Agenda Date:	August 14, 2025	Application ID:	SP 2024-0007
Project:	Shops at Pembroke Gardens Residential	Project Number:	PRJ 2024-0009
Project Planner:	Joseph Yaciuk, Assistant Director		
Owner:	FR Pembroke Gardens LLC.	Agent:	Dwayne Dickerson Esq.
Location:	South of Pines Boulevard, between I-75 and Southwest 145 Avenue	Acreage:	+/- 2.7 Acres
Existing Zoning:	PCD (Planned Commercial Development)	Proposed Zoning:	MXD (Mixed Use Development)
Existing Land Use:	Commercial	Commission District:	4
Reference Applications:	MSC 2025-0012, ZC 2024-0002, ZC 2024-0003, SUB 2024-0001, ZC 2018-03, ZC 2015-05, ZC 2009-03, ZC 2008-03, ZC 2005-04, AM 2005-04		
Applicant Request:	The development of 308 residential units with associated parking, traffic circulation, landscape, and lighting on a +/- 2.7-acre parcel within the Pembroke Gardens site		
Staff Recommendation:	<p>Transmit to the City Commission with a favorable recommendation subject to the following conditions:</p> <ol style="list-style-type: none"> 1. City Commission approval of the underlying zoning change request (Map Amendment ZC 2024-0002) from Planned Commercial Development (PCD) to Mixed Use Development (MXD), inclusive of executio

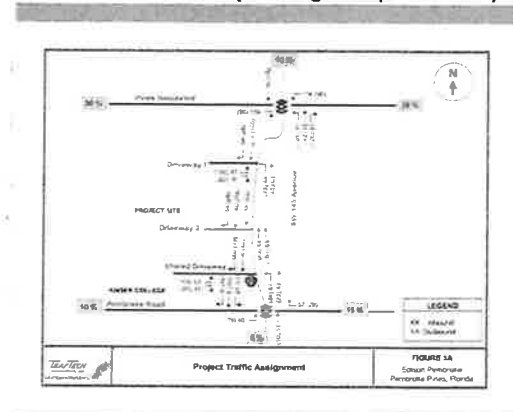
1) Per ITE guidelines, for developments that generate 200 to 500 peak hour trips, all major intersections within a 0.5-mile radius of the site should be included. Among the listed intersections, one intersection is not included in the analysis as highlighted in red below:

- Pines Blvd (Signalized)
- SW 3rd Street
- SW 5th Street (Signalized)
- SW 8th Court (Missing)
- SW 146th Terrace
- Pembroke Road (Signalized)

Note, the NW 136th Street/Pines Blvd. intersection is included for Building B only in the study. SW 8th Court is missing from the data collection for both the buildings. However, since this is an UNSIGNALIZED intersection with driveways to the north/south, it is anticipated that only through trips would impact this location. Therefore, the improvements would be limited here, especially since it's so close to the signal on SW 5th Street. The study locations including the proposed intersection is shown in the following figure.
